Report on Assisted Travel at Belfast City Airport

Consumer Council for Northern Ireland

09 September 2025

Figure 1: Electric Vehicle Charging Bays

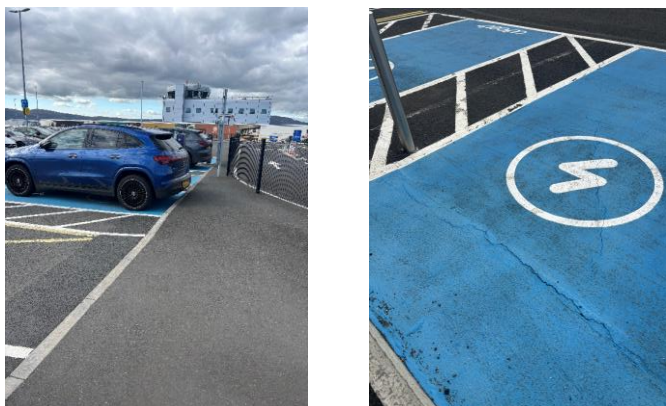
The electric vehicle charging bays in the short stay car park are marked out in blue and white (Figure 1). This is the same colour scheme used to denote blue badge parking bays which can be confusing. The group considered that green is a commonly recognised colour for electric vehicle charging bays.

- Consider providing car park pricing as displayed at the entry barrier before this point, for example online.
- Change the colour of electric vehicle parking bays to green to differentiate them from blue badge bays.
